Docket No. 50-336
B19004

Millstone Power Station, Unit No. 2
Response to Request for Additional Information on RR-89-48 for the
Nozzle Inspection Ultrasonic Test Coverage Requirements in Order EA-03-009

Response to Request for Additional Information on RR-89-48 for the
Nozzle Inspection Ultrasonic Test Coverage Requirements in Order EA-03-009

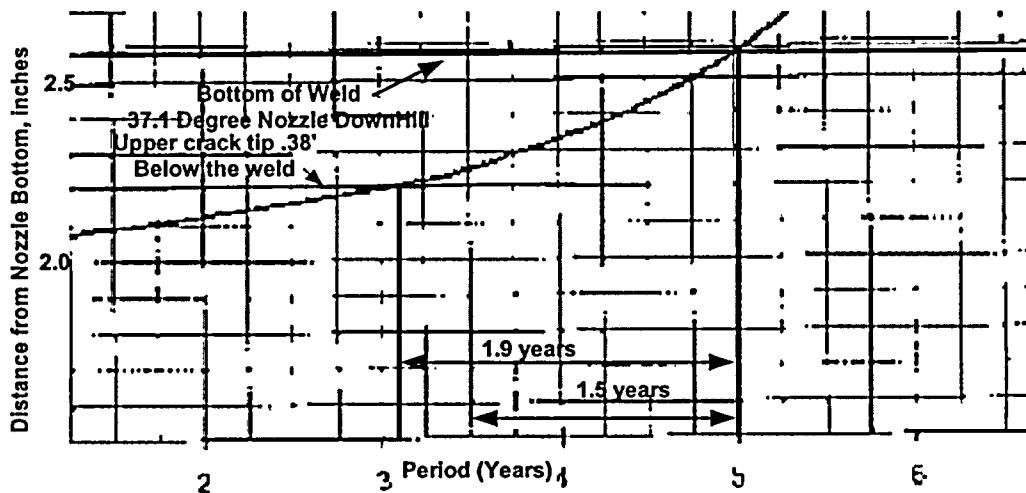
8. *Discuss the basis for the 0.38 inch level below the J-groove weld. From what point on the J-groove weld will the 0.38 inches be measured?*

The basis for the 0.38 inch criteria came from an evaluation of the data collected during the previous inspection in March 2002 and the application of this information to the crack growth prediction curves found in the WCAP. As discussed in the response to question 12 below, the point that UT is calling the bottom of the weld is where weld metal stops. This is conservative since the theoretical tangent of the fillet weld is closer to the head. The data from March 2002, had a number of points

clustered around 0.38 inches below the weld and 0.30 inches below the weld. A check of the 0.30 dimension on the crack growth prediction curves showed that for most of the nozzles the predicted time for a through wall flaw to grow to the weld was less than 1.5 years. At the 0.38 inch dimension, the predicted times were as shown in the Millstone submittal. The Figure below shows the graphical determination of the time until a crack 0.38 inches below the weld reaches the bottom of the weld for the 37.1 degree penetration which turned out to be the most limiting case. This Figure is an enlarged section of Figure 6-15 from WCAP 15813-P.

SECTION VIEW B-B
CLOSURE HEAD LOOKING NORTHEAST
AT NOZZLES 14, 34 & 59
SCALE: NONE

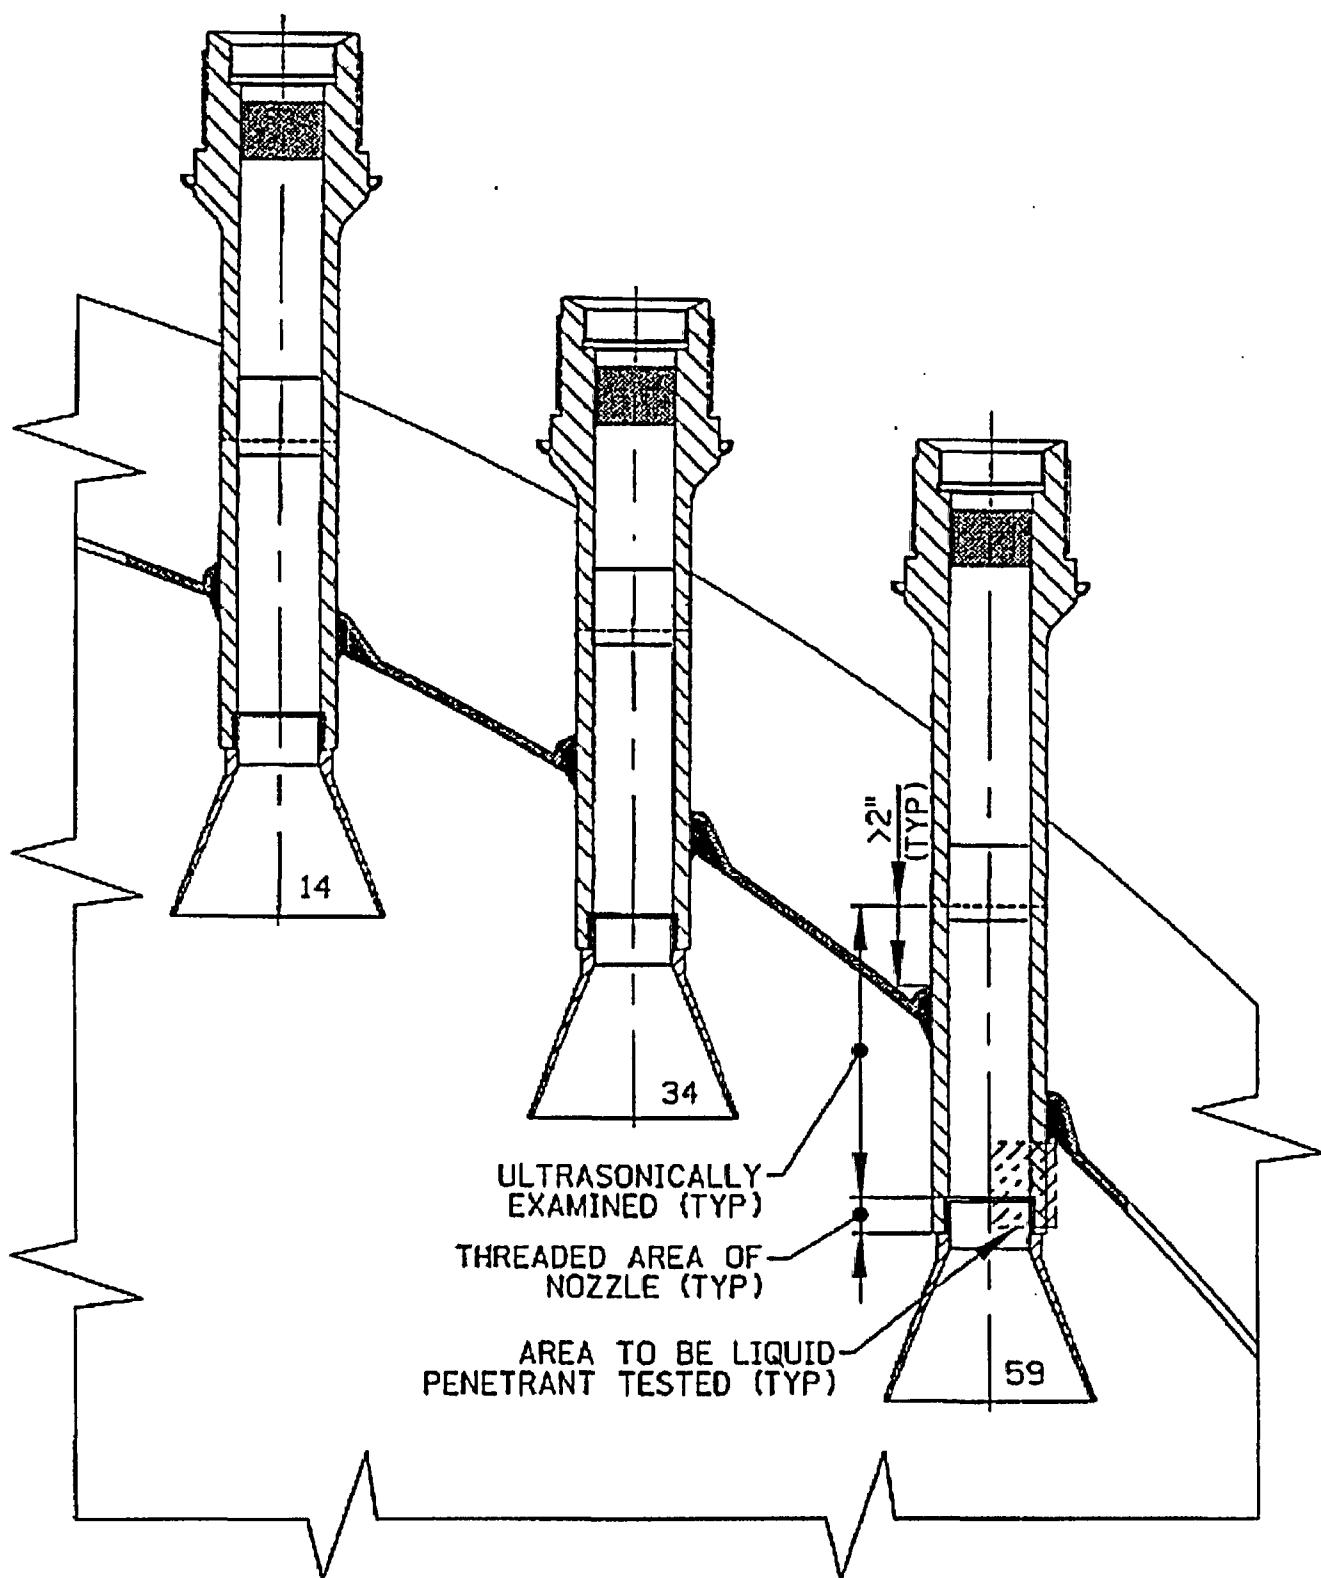
2. *Provide the scope of the PT surface examinations, and the flaw tolerance on each CEDM penetration. What is the proposed area to be examined? Will the examination be 360 degrees around the nozzle? Provide a drawing or drawings showing the area to be examined by PT. Will the surface examination be performed to the bottom of the nozzle?*

UT examination coverage obtained is a full 360° around the nozzle. The proposed area to be PT examined will be 180° of the nozzle Outside Diameter (OD) centered on the downhill side, (see attached Figure, Section View B-B), from the toe of the weld at the lowest point on the weld, extending down to cover approximately 3/4 inches of the nozzle base material. This examination will overlap the area that was examined ultrasonically and extend below to obtain the desired coverage. An attempt will be made to avoid examining the end of the nozzle, (approximately 1/4 inches from the bottom), because the bleed-out of the penetrant from the mating surface between the nozzle end and funnel could mask the area of interest.

Performing a liquid penetrant examination on the nozzle base material on the uphill side of the nozzle, would result in an increase in radiological exposure, (approximately double), without a commensurate increase in the level of quality or safety for this inspection. A liquid penetrant exam of the uphill side would involve climbing down the ladder, moving the ladder, and climbing back up the ladder to perform the additional PT on that side of the nozzle.
